# MINERALS PROGRAM INSPECTION REPORT PHONE: (303) 866-3567

MINE NAME:	MINE/PROSPECTING ID#:	MINERAL:	COUNTY:				
Tezak No 2 Pit	M-1981-080	Sand and gravel Fremont					
INSPECTION TYPE:	INSPECTOR(S):	INSP. DATE:	INSP. TIME:				
Monitoring	Timothy Cazier, P.E.	June 16, 2021	10:15				
OPERATOR:	OPERATOR REPRESENTATIVE:	TYPE OF OPERATION:					
Tezak Stone & Aggregate Supply, Inc.	Nathan Tezak	112c - Construction Regular Operation					
REASON FOR INSPECTION:	BOND CALCULATION TYPE:	BOND AMOUNT:					
REASON FOR INSPECTION: Normal I&E Program	BOND CALCULATION TYPE: Partial Bond	<b>BOND AMOUNT:</b> \$55,535.00					
			NCY:				
Normal I&E Program	Partial Bond	\$55,535.00	NCY:				
Normal I&E Program  DATE OF COMPLAINT:	Partial Bond POST INSP. CONTACTS:	\$55,535.00 <b>JOINT INSP. AGE</b>

Photo 2. Active highwall, opposite Hwy 50 visual berm (looking NE; note topsoil layer).

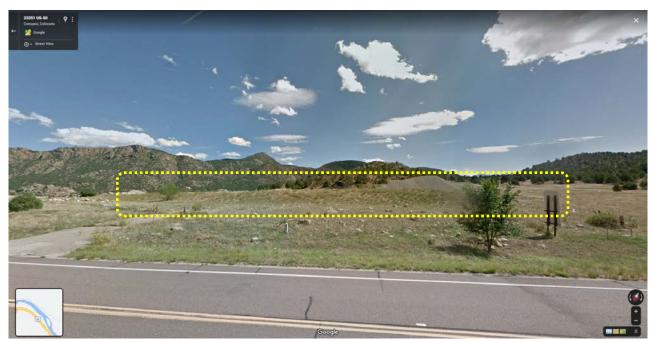
<u>Topsoil:</u> Topsoil is stockpiled in two locations, both on the south side of the pit: one near the center (see **Photo 10**); and the other in the southwest corner (see **Photo 11**). The topsoil horizon can be seen in **Photo 2**.
